and Management Parameters for 10 Mb/s Operation and Associated Power Delivery over a Single Balance

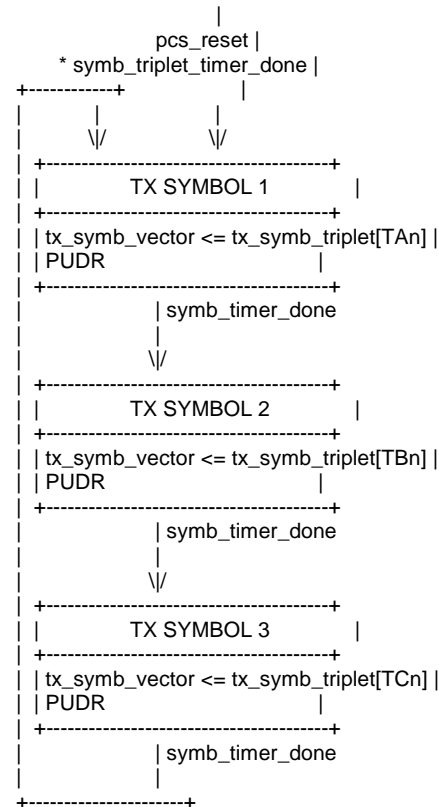
Is it correct that 'The PCS Transmit function shall conform to the PCS Transmit state diagram in Figure 146-5 ...' and that 'In each symbol period, PCS Transmit generates a symbol An provided to the PMA ...'? The PCS Transmit state diagram in Figure 146-5 changes state based on STD being true, with STD being an alias for symb_triplet_timer_done, and the output of the PCS Transmit state diagram is tx_symb_triplet which is defined in subclause 146.3.3.1.1 'Variables' as 'A triplet of ternary symbols generated by the PCS Transmit function after 4B3T encoding.'

I think the problem is that there is another function within the PCS Transmit function that is missing from the PCS Transmit state diagram in Figure 146-5, the 'multiplexor' shown in Figure 146-6 'PCS transmit symbol generation'. This 'multiplexor' function operates at the symbol clock rate and serialises the tx_symb_triplet code-groups output by the PCS Transmit state diagram into individual symbols.

This may also explain when subclause 146.3.3.1.3 'Timers' defines the symb_timer that is not used in the PCS Transmit state diagram in Figure 146-5.

[4] Add a new subclause 146.3.3.2.2 titled 'Timers'. Move the symb_timer definition from subclause 146.3.3.1.3 Timers to this new subclause.

[5] Add a new subclause 146.3.3.2.4 'Abbreviations' that reads:

[6] Insert a new Figure 145-6 shown below (view using a non-proportional font such as courier), renumbering the following figures as required.

[7] Add text to subclause 146.3.3 'PCS Transmit' that reads 'The PCS Transmit function shall conform to the PCS Transmit state diagram in in Figure 146-5 and the PCS Transmit multiplexor state diagram in 146-6, and their associated state variables, functions, timers, and messages.'
